California High-Speed Train Project

Request for Proposal for Design-Build Services

RFP No.: HSR 11-16
Design Variance Report

06/29/2012 ADDENDUM 3 - RFP HSR 11-16

CONTRACT NO.
DRAWING NO. UT-C4043
SCALE AS SHOWN
SHEET NO.

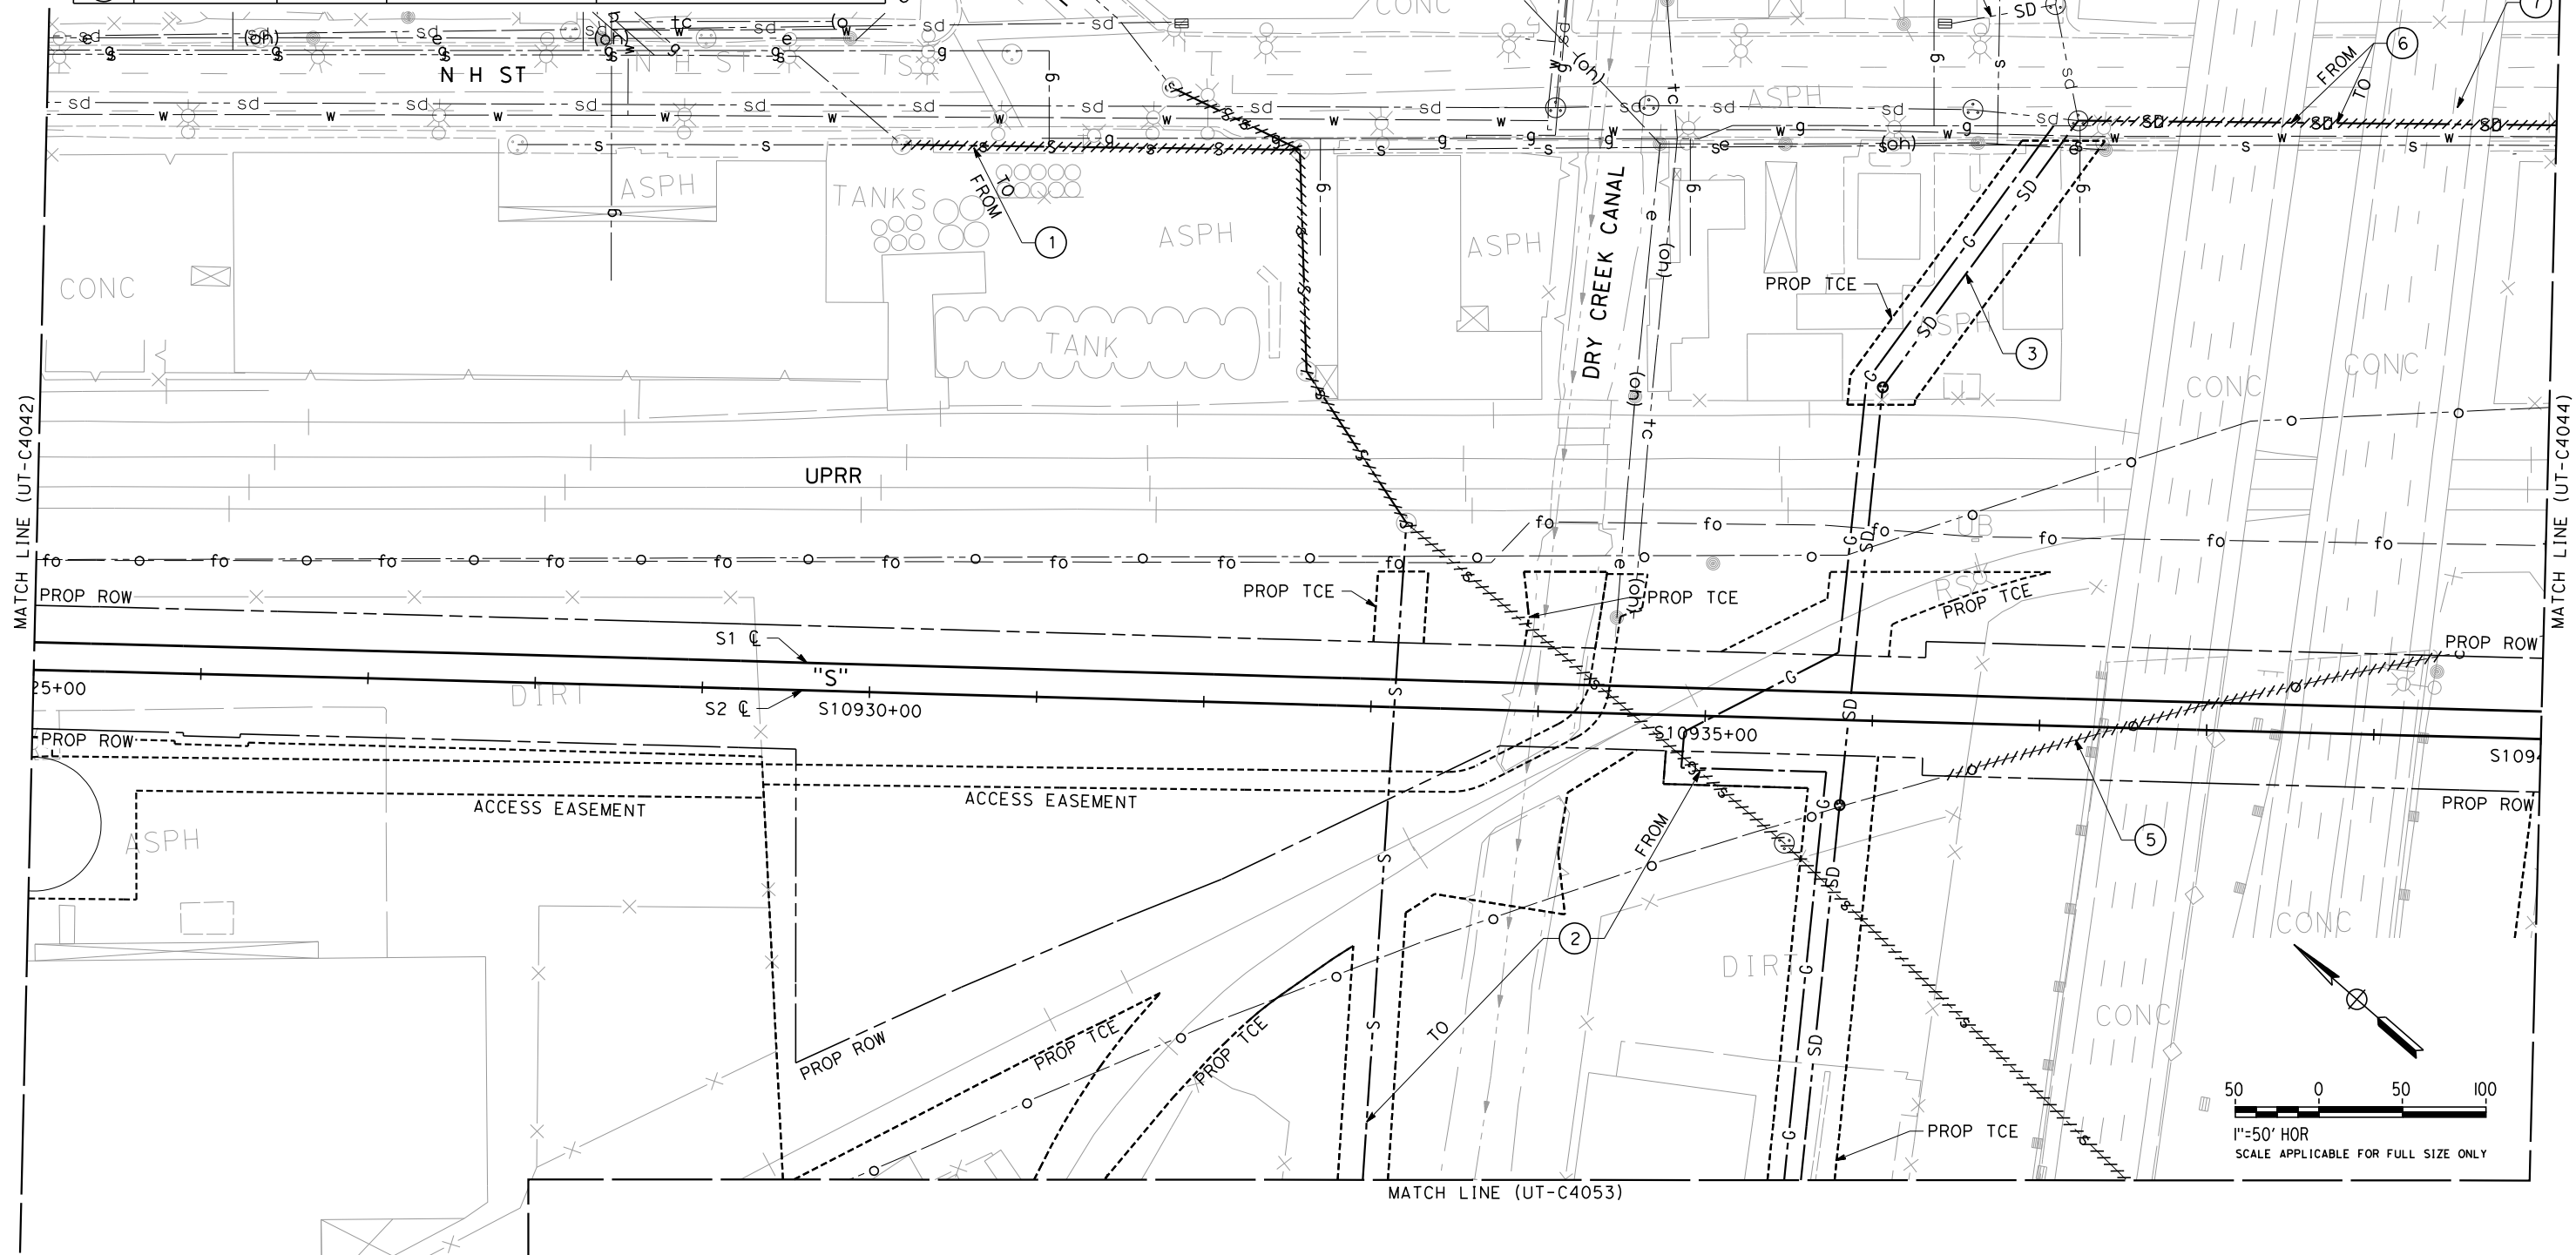
CHSTP DESIGN REQUIREMENT Include reference to drawings, design criteria, technical memos, specifications	TM 2.1.2 Rev 0 – Alignment Standards for High-Speed Train Operations TM 3.2.1 Rev 1 – OCS Requirements
DESIGN CRITERIA REQUIRING A VARIANCE	<p>Below-standard clearance of 24ft is proposed to the CHSTP structure below the proposed 30-inch sewer line (STA10933+14), the Dry Creek canal (STA10934+00) and the 60-inch storm drain (STA10935+86).</p> <p>This meets the standard clearance to an existing structure but does not meet the 27-foot clearance required for a new structure.</p>
REASON FOR REQUESTING A VARIANCE	<p>The 30-inch sewer line is currently located at STA10934+56 with an existing invert level of 273.8ft. The invert elevation needs to be maintained at the point of relocation for the system to continue to operate as a gravity system.</p> <p>Dry Creek is located at STA10934+00 with an existing invert level of 281ft, which is to be maintained.</p> <p>The 60-inch storm drain is replacing two separate drain lines at STA 10940+21 and STA10945+18 that would not meet the standard clearance to an existing structure. The relocated invert elevation of 275.7ft needs to be maintained for proper operation of the storm drain as a gravity system.</p> <p>CHSTP is grade separated below Dry Creek. The creek is to be culverted and is required by the PMT to be structurally independent of the proposed CHSTP structure.</p> <p>CHSTP is grade separated below the 30-inch sewer line and the 60-inch storm drain. Both lines will be independent of the proposed CHSTP structure.</p> <p>The CHSTP alignment is to be as shallow as possible to reduce the trench structure cost and the crossover distances to the proposed station.</p>

<p>If the clearance is increased to 27ft, then either an amalgamated Dry Creek culvert/CHSTP structure or a deeper and longer trench structure will be required.</p> <p>The PMT has previously rejected the amalgamated structure in order to separate the maintenance and other liabilities of the canal structure from that of the CHSTP structure.</p> <p>Pumping stations would be necessary to lift the storm drain and sewer lines in order to gain the 27ft clearance required by the Technical Memoranda. The City of Fresno and the Fresno Metropolitan Flood Control District are both highly opposed to pump stations due to increased maintenance and associated liabilities (see Minutes of Meeting, Appendix A).</p> <p>The deeper and longer trench will be significantly more expensive. Deepening the trench may also require wider trench walls and therefore increased right-of-way width.</p> <p>The longer trench structure will lengthen the crossover to station distance. This is already a design variance and will further impact operations.</p>
